Date: November 24, 2004
Refer To: ER2004-0671

SUBJECT: RESPONSE TO THE NOTICE OF DISAPPROVAL FOR THE INVESTIGATION WORK PLAN FOR MATERIAL DISPOSAL AREA B AT TECHNICAL AREA 21, SOLID WASTE MANAGEMENT UNIT 21-015, DATED OCTOBER 22, 2004, LOS ALAMOS NATIONAL LABORATORY, EPA ID#NM0890010515

**Response to the Notice of Disapproval for the Investigation Work Plan for
Material Disposal Area B at Technical Area 21, Solid Waste Management Unit 21-015,
Dated October 26, 2004**

Figure 1. MDA B site plan

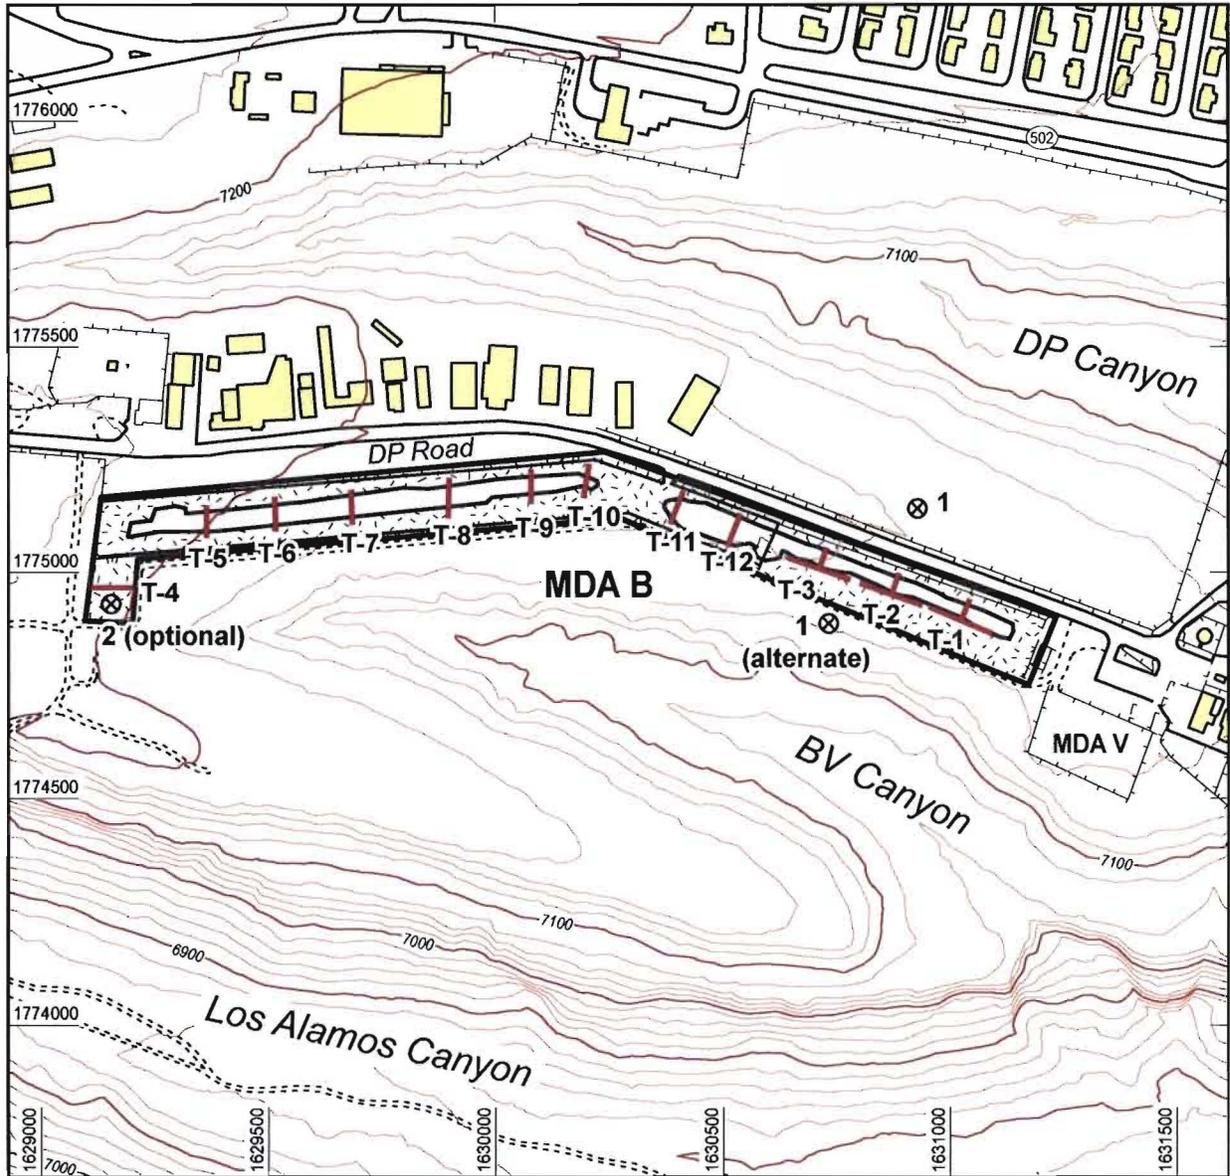
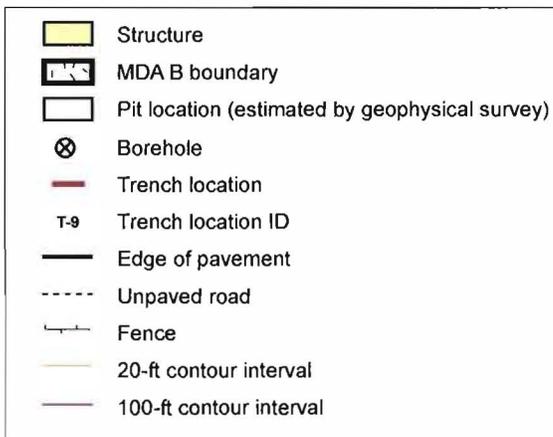
1. *All figures must include pertinent features and structures, underground utilities, and existing well and borehole locations. For example, Figure 1 (MDA B site plan), does not show the location of the abandoned radioactive liquid waste line along the southern boundary of the site, or the Los Alamos County sanitary sewer lift station near the southeast corner of the site. Also, Figure B-26 appears to be inaccurate with respect to the distance between the MDA B and MDA V boundaries. This information could affect the proposed sampling locations and therefore the overall work plan. Rather than resubmit these figures, ensure these changes are reflected in the Investigation Report.*

NMED does not agree that the 1998 angled boreholes define extent of contamination at MDA B. Large areas of the estimated pit locations (estimated by the geophysical survey) shown on Figure 1 (MDA B Site Plan) were not sampled during the 1998 sampling event (subsurface), nor did the Permittees complete a full analytical suite on the 1998 samples. Only TAL metals, SVOCs, americium, tritium, isotopic plutonium, isotopic uranium, and strontium were analyzed. The Permittees must excavate four additional trenches (See attached Figure) to more adequately ascertain the likely locations and contents of the estimated pit locations within MDA B. The Permittees must also drill two vertical boreholes to the base of the Cerro Toledo interval (See paragraph 5 comment below for additional information). In accordance with Section IX.B.2.d of the Consent Order appropriate technology must be utilized to detect vapors during drilling and sampling operations. If vapor-phase contamination is detected during drilling activities, vapor-monitoring wells will be installed. If groundwater (perched or regional) is encountered during drilling activities or if geophysical results indicate possible zone(s) of saturation, monitoring wells must be installed.

Also included is the Certification by the ENV-RS Project technical representatives and replacement Figure 1 to the investigation work plan for MDA B.

1. The investigation report site plan figures will be revised to show pertinent features and structures, underground utilities, and existing well and borehole locations.

The Laboratory will clarify that 1998 angled boreholes will be used in addition to work proposed in this work plan to define the nature and extent of contamination. The Laboratory will add four additional trenches (these new trenches are numbered T-2, T-6, T-10, and T-11) to the investigation work plan based on NMED's recommendation. The locations of the additional trenches are shown on the revised MDA B Site Plan (Figure 1) included with this response. All analyses proposed in this investigation will contain a full analytical suite as required by the September 1, 2004 proposed Consent Order.

The Laboratory will revise the work plan to include the drilling of up to two boreholes to the Cerro Toledo interval as part of this investigation. One borehole will be located north of the Eastern one-third of MDA B near the chemical waste disposal trenches, as shown on the revised MDA B Site Plan (Figure 1). This location was selected to address the potential contamination associated with the chemical trenches and positioned based on a northeast-southwest fracture orientation in the tuff. An alternate location for this borehole was also selected to address the paleotopography of the Cerro Toledo interval. The alternate location southwest of the chemical disposal trenches (Figure 1) will be

used if information from drilling at adjacent MDA V indicates the Cerro Toledo interval dips to the south in this area. The second borehole will be drilled to the Cerro Toledo interval near the far western side of MDA B (Figure 1) where the suspected north-south oriented chemical disposal trenches are located. However, this borehole will be drilled only if the suspected chemical disposal trenches are present and confirmed to contain liquid chemical waste, or if elevated moisture, trench water, etc., are detected, based on exploratory trenching in this area. After the MDA V data has been evaluated and trenching at MDA B is complete, the Laboratory will confer with NMED on the exact locations and number of Cerro Toledo boreholes.
